A417 Missing Link  
TR010056

8.26 Comments on Responses  
received by Deadline 4

**Comments on Responses received by Deadline 4**

<b>Regulation Number:</b>	
<b>Planning Inspectorate Scheme Reference</b>	TR010056
<b>Application Document Reference</b>	8.26
<b>Author:</b>	A417 Missing Link

**Figure 2-1 Location of the 'historic bridge' to the northeast of Cowley Manor**

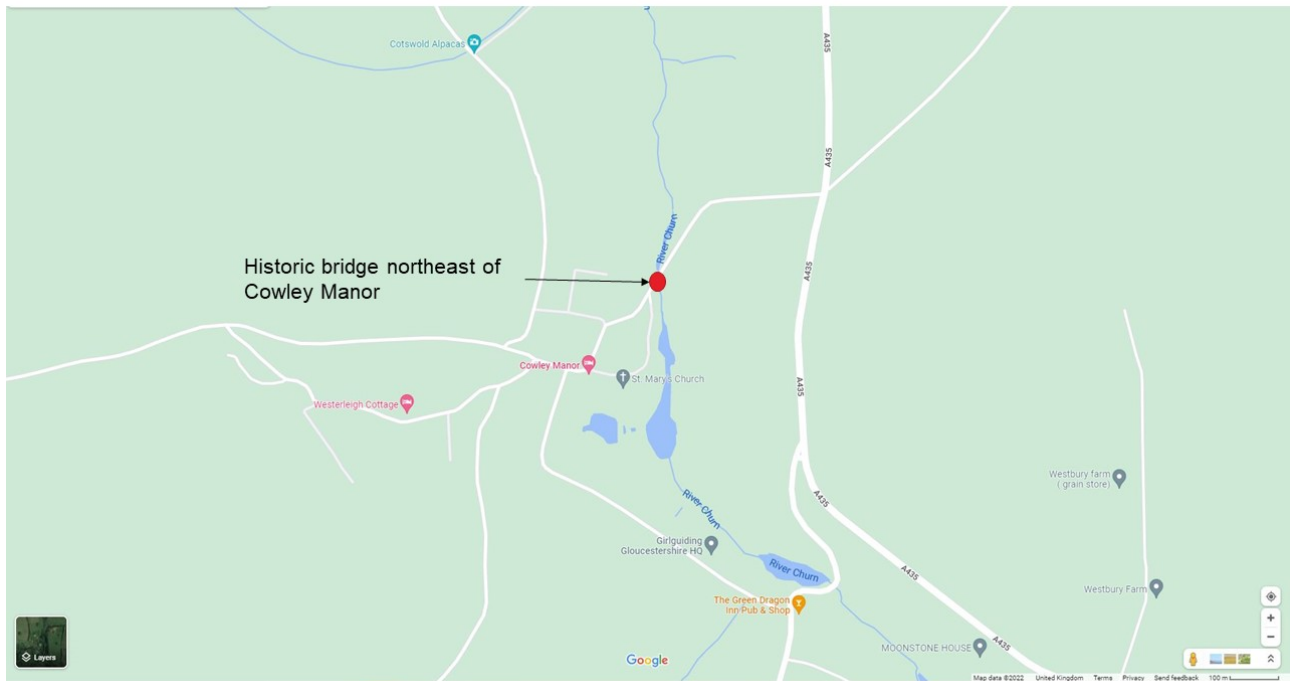
- 2.8.1 At Issue Specific Hearing 4 (ISH4) on the draft DCO, held 3 March 2022, National Highways was assigned Hearing Action Point ISH4-AP1 which stated:
- "Provide traffic data regarding usage of the 'historic bridge' northeast of Cowley Manor."*
- 2.8.2 The location of the 'historic bridge' northeast of Cowley Manor is provided in Figure 2-1.

- 2.8.3 National Highways has extracted the forecast traffic flows from the scheme traffic model that would pass over this 'historic bridge' (Figure 2-1 provides the location of this 'historic bridge') for the 2041 Do-Minimum (DM) and Do-Something (DS) scenarios. The DM scenario would not include the scheme proceeding, whereas the DS scenario includes the proposed scheme.

- 2.8.4 The two-way Annual Average Daily Traffic (AADT) figures decrease from 793 in the 2041 DM to 494 in the 2041 DS. By direction the AADT traffic flows for the DM and DS scenarios would be:

- 2041 DM eastbound 388, 2041 DS eastbound 209
  - 2041 DM westbound 405, 2041 DS westbound 285.
- 2.8.5 It should also be noted that this link was not part of the formal model validation represented in the ComMA (Document Reference 7.6, APP-422). A traffic count from 2015 however does exist for the Cowley village junction on the A435. Traffic counts are utilised in the development of the base traffic model and allow comparisons between the observed and modelled traffic flows to take place. This is the calibration/validation process of the base traffic model and ensures that the model reacts realistically in relation to the distribution of traffic. The Transport Analysis Guidance (Unit M3-1 Highway Assignment Modelling) sets out the criteria that the model needs to achieve, these are provided in Table 8-1 of the ComMA Report.
